SERVICE LETTER

**SUBJECT: PRATT & WHITNEY CANADA SERVICE BULLETIN NO: 14251R1 (02-12-96)
TURBOPROP ENGINE - BLEED OFF VALVE (BOV) COVER, INSPECTION AND/OR
REPLACEMENT.**

PRATT & WHITNEY CANADA
SERVICE BULLETIN

TURBOPROP ENGINE
BLEED OFF VALVE (BOV) COVER - INSPECTION/REPLACEMENT OF

COMPRESSOR BLEED VALVE
(LATEST VERSION SHOWN,
EARLIER BLEED VALVES HAVE
THE SAME COVER ASSEMBLY)

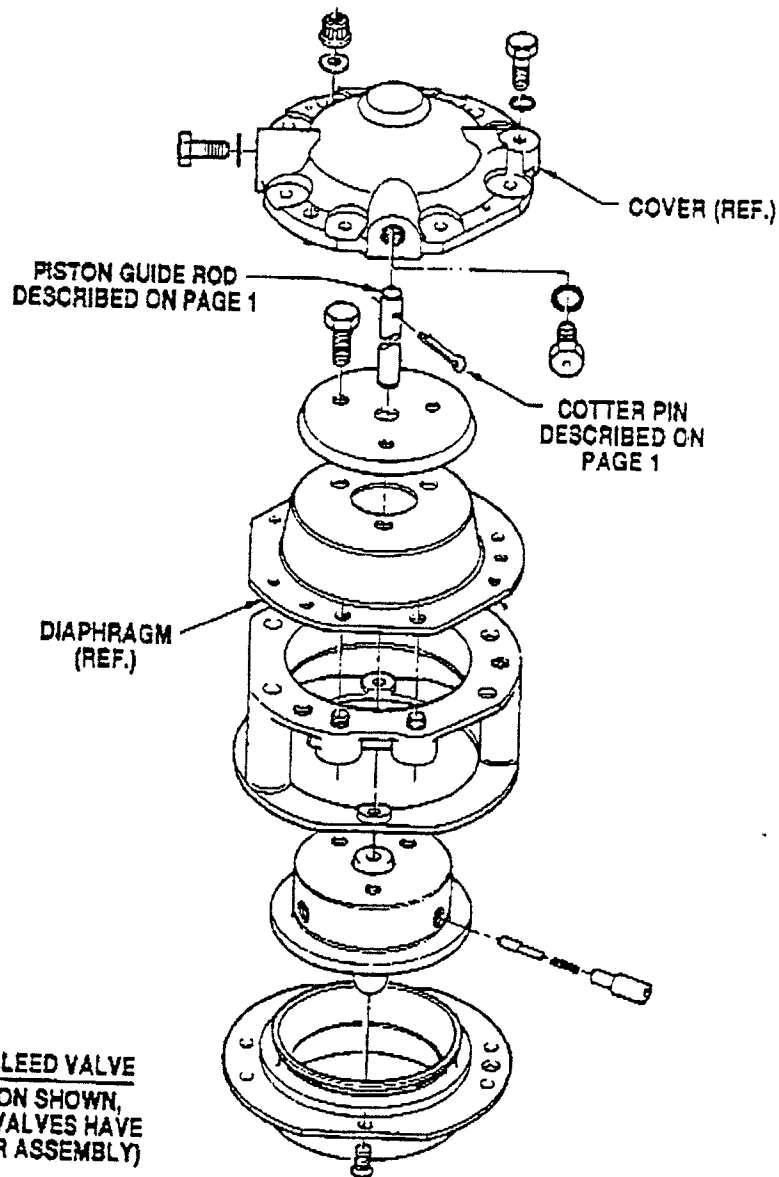
Investigation of the two bleed valves revealed a broken cotter pin, the pieces of which interfered with movement of the bleed valve piston. The illustration on page two shows the location of the cotter pin. The cause of cotter pin breakage has been identified as stress loading from the piston guide rod, which was found to be installed improperly in the two cases mentioned above. The guide rod was found to be loose, a deviation from the engineering drawing requirements. See the page two illustration for detail.

P&WC will issue the above referenced Service Bulletins (November 1996) that recommend a one time inspection of all bleed valves installed on engines within a serial number range. All spare bleed valve assemblies should also be inspected. In addition to providing instructions for the inspection, the Service Bulletins will refer to Commercial Support Program Notification No. A96036 which will provide for labour allowance, free issue of consumables and a replacement bleed valve cover if required.

Compressor Bleed Valve Cover Inspection and Replacement Area
Figure 1 (Sheet 1 of 2)

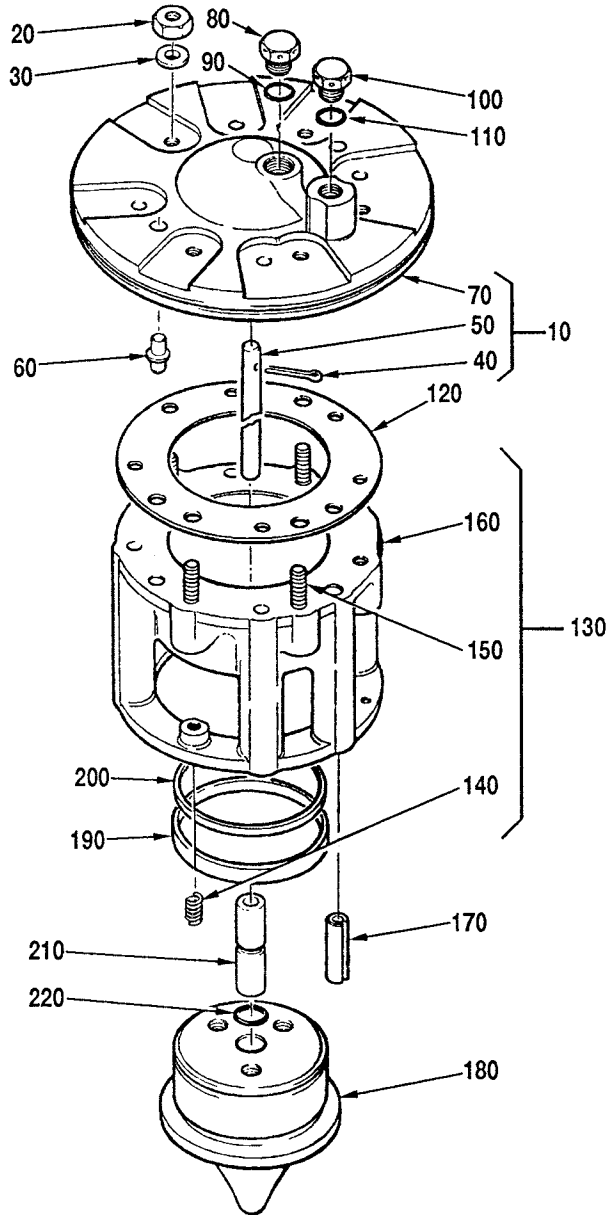
A. Refer to the maintenance manual and to Figure 1, for removal and installation instructions:

(c) Inspect middle section of the cotter pin for marks, dents, grooves or any evidence of pitting, pinching or any wear (Ref. View A).

(d) Special attention should be placed on the interface areas between the guide shaft pin and the cover bore where the cotter pin may be subjected to shear stress as defined in Figure 1.

NOTE: If this condition is found, a new compressor bleed valve cover assembly must be installed (Ref. Para. 3.A.3).
